Product Change Notification: PCN-23-179047
Customer: Avnet EMG (429291) Location: North Reading Agreement: Agreement Unknown
PCN Date: 21-JUN-23

General Product Description: (Text limited to 120 characters)
Mini UMNL - Header Assembly

Existing Resin

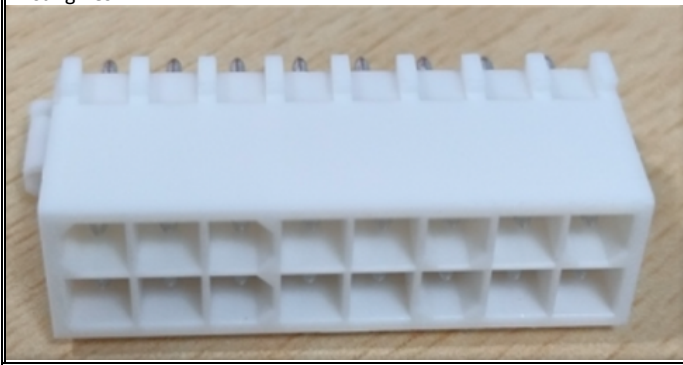
Adding an additional resin (Nylon) option for this product. Necessary qualification tests as per the Product specification were performed and passed.
